## **– Bytek Volkswagen Expansion and Renovation Project**

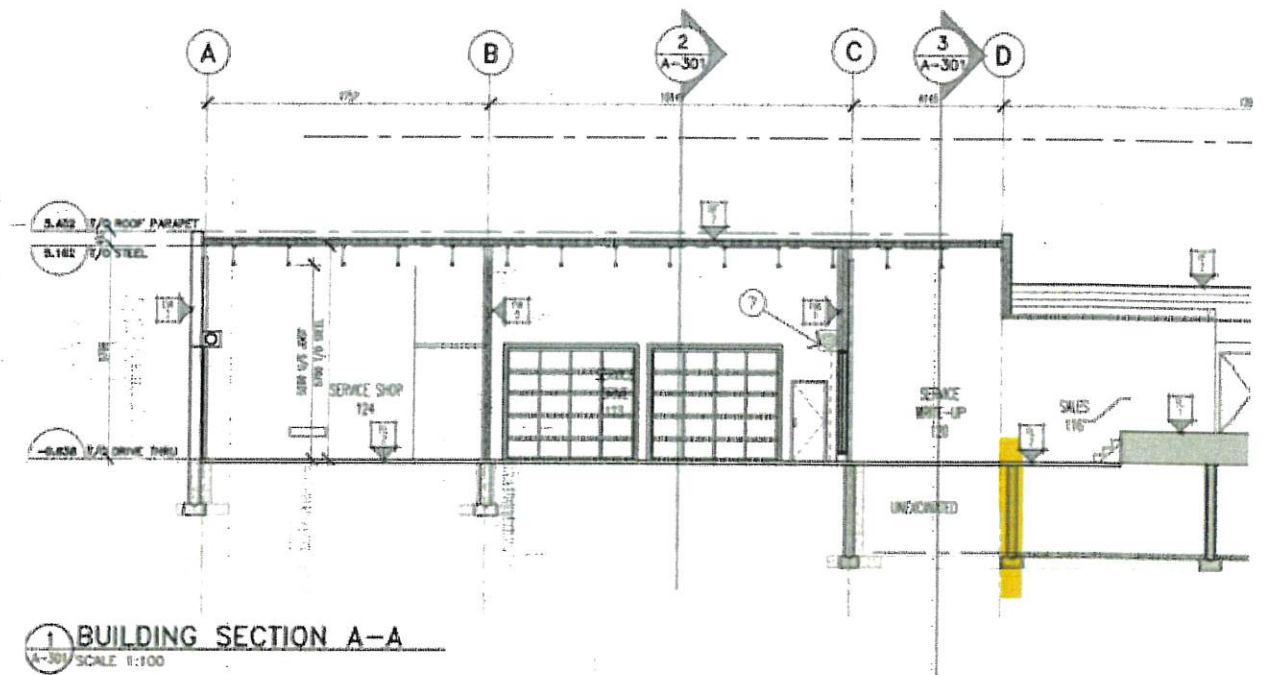
- b. If no foundation and footing are required under this wall, the detail on 1/A-301 needs to be changed.
4. Refer to structural drawing S100 (see the snapshot below), are foundation and footing required for the portion highlighted in yellow?

Q4. there is not existing foundation wall on D based on the existing structural drawings.

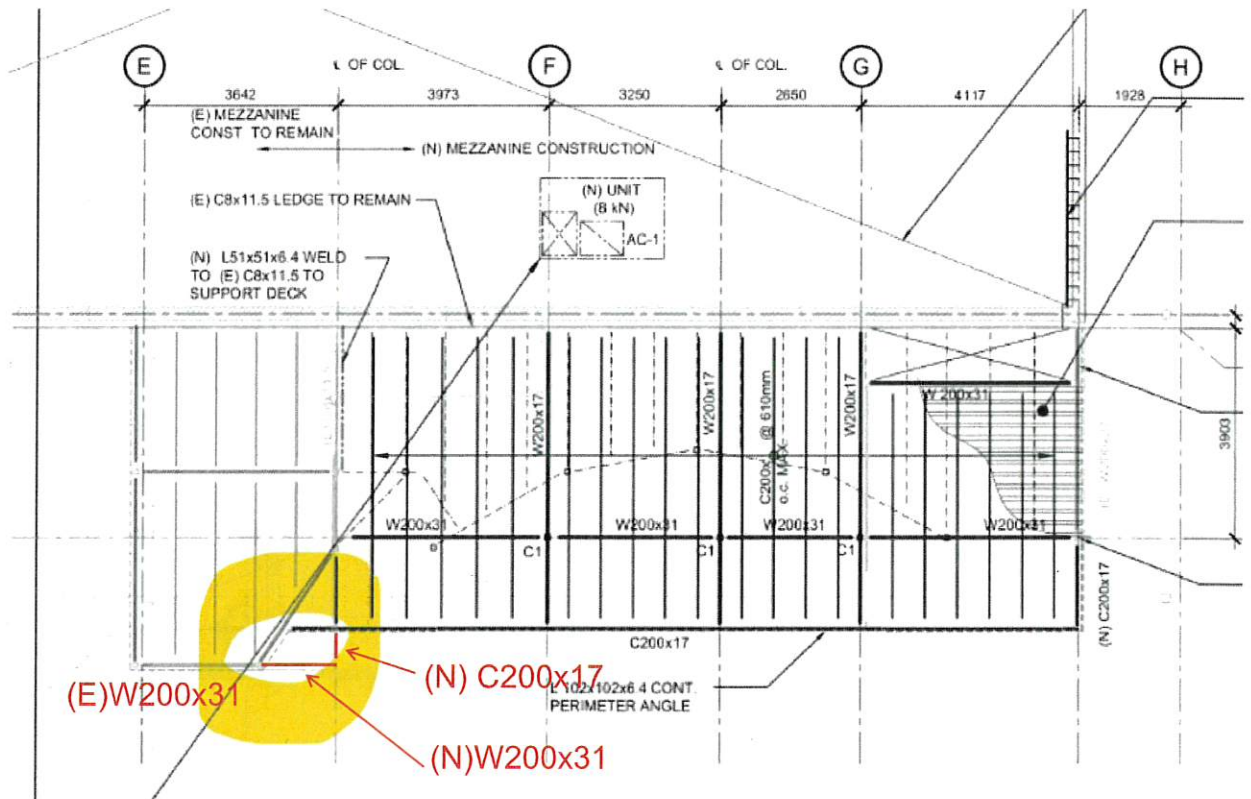
5. Refer to structural drawing S101 (see the snapshot below), please provide details on what need to be done with the existing columns in yellow.

Q5. Infill old column opening with a 1/4" plate at underside of floor and 2.5" of concrete topping on top of new steel plate infill. RN BPA

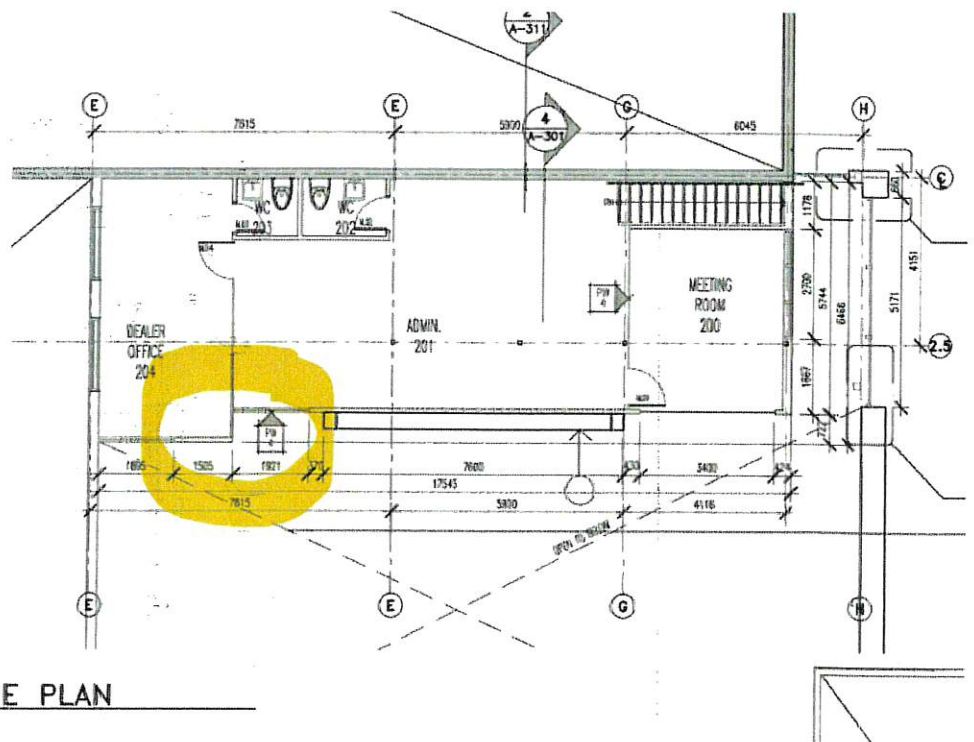
6. Refer to structural drawing S102, similar to item #1 above, the new addition area between grid B and D needs to be revised to match architectural drawings.
7. Refer to structural drawing S102 (see the snapshot below), the portion in yellow doesn't have the same shape as on architectural drawing.

Q7. Extend existing W8x21 (W200x31 to square out floor and infill Concrete on Deck)  
Provide full moment and shear capacity for new W200x31 to existing W200x31
